Response to Review 1

The manuscript describes a dataset measured by the Lake Taihu Eddy Flux Network which consists of seven eddy covariance (EC) flux stations over Lake Taihu and one EC flux tower over the land as a reference. Although EC flux measurements over inland waters have increased worldwide, such a flux network over a single lake is rare. Besides the uniqueness of the dataset stated in the manuscript, it could provide a valuable perspective in terms of spatial variability in fluxes and associated controlling factors. The dataset should benefit to broader communities in micrometeorology, hydrology, remote sensing, water resource managements, and modeling to name a few. The descriptions of the sites, instruments, and methods are clear and adequate. The dataset is of high quality as also reflected by their published research articles (I read most of them in the past). The manuscript is well written and structured. I would recommend its publication.

Figure R1. Daily water level (above local sea level) in Lake Taihu

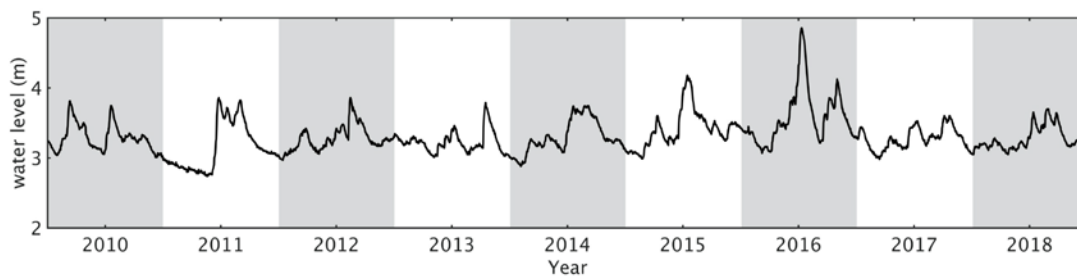
Do you have water level measurements or provide information that helps users to find how water levels vary?

The daily water level is monitored by the TAIHU BASIN AUTHORITY at five locations around the lake (<http://www.tba.gov.cn/slbthlyglj/sj/sj.html>), as shown in Figure R1 below. Using this time series, we have constructed the water depth for our eddy covariance sites (Figure R2, added to the revision as Figure 2).

Figure R2 Water depth at the eddy covariance sites

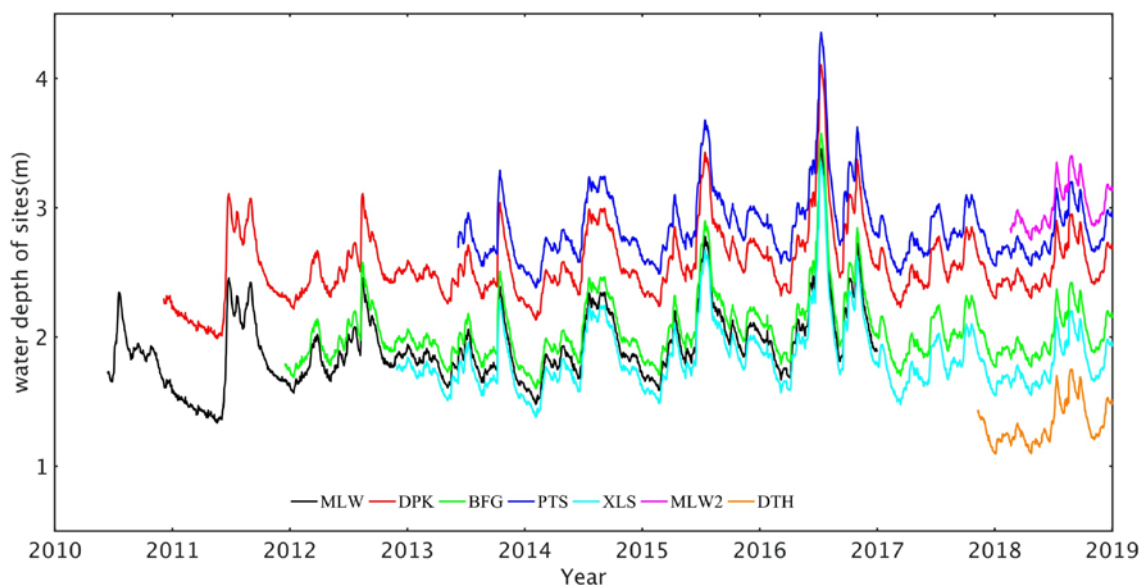
I understand water levels vary, but would it be good to provide the lake bathymetry also with the tower locations to give users a better understanding of the lake?

“The lake water level is monitored daily by the Taihu Basin Authority (<http://www.tba.gov.cn/>) at five locations around the lake. Using the water-level time series, we have constructed the water depth for our eddy covariance sites (Figure 2).”
